## **Proposal for Supplement 2 to the 02 series of amendments to Regulation No. 129**

### **Submitted by the expert from France\***

Load application device II

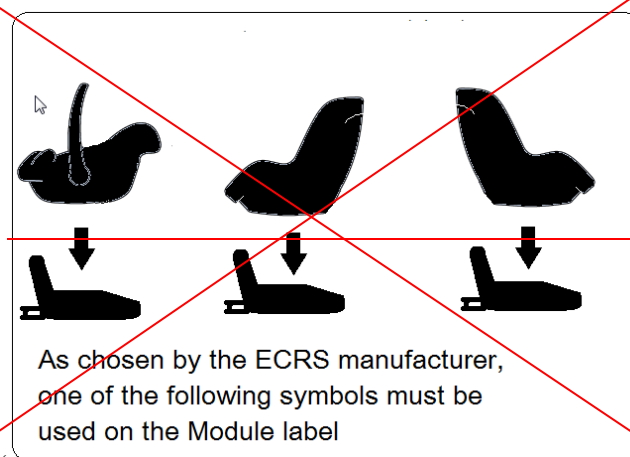
Annex 214, amend to read:

Stretch length	(+/- 5 mm)					
	Q 0	Q 1	Q 1,5	Q 3	Q 6	Q 10
Main belt (A)	1,740 mm	1,850 mm	1,900 mm	2,000 mm	2,000 mm	2,100 mm
Hip belt (B)	530 mm	560 mm	600 mm	630 mm	660 mm	<del>700</del> 800 mm
Lower dimension (C)	125 mm	150 mm	150 mm	170 mm	200 mm	200 mm
Mid dimension (D)	270 mm	300 mm	350 mm	380 mm	380 mm	400 mm

Annex 2 figure, replace module pictures in the last figure in Annex 2 as follows::

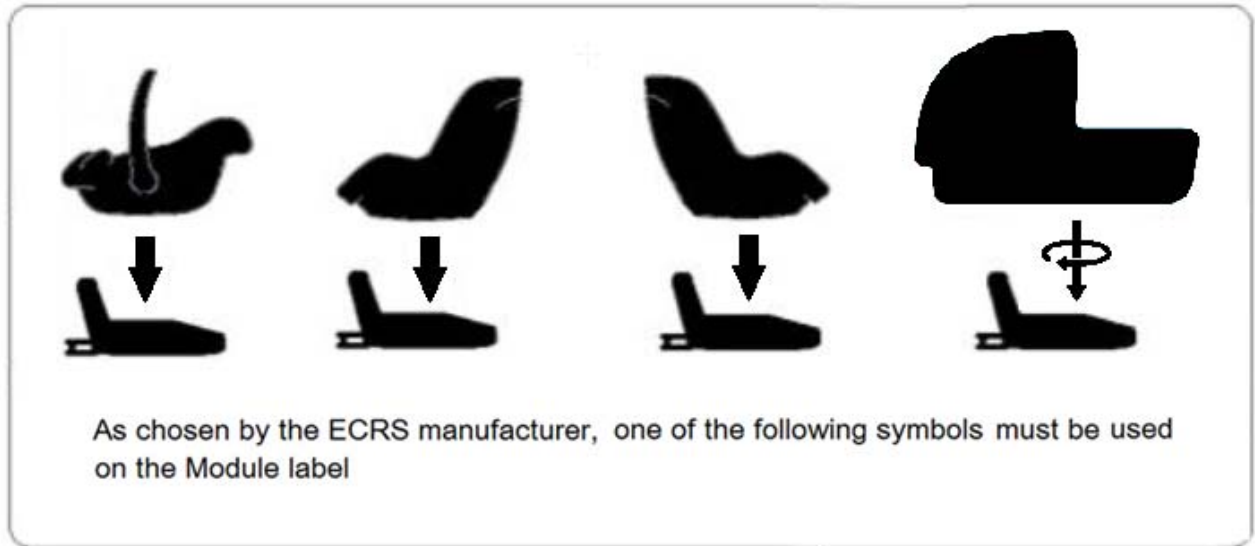
In addition, Module label was agreed in the 62nd IG meeting but the image was missed in the informal document GRSP-60-08.
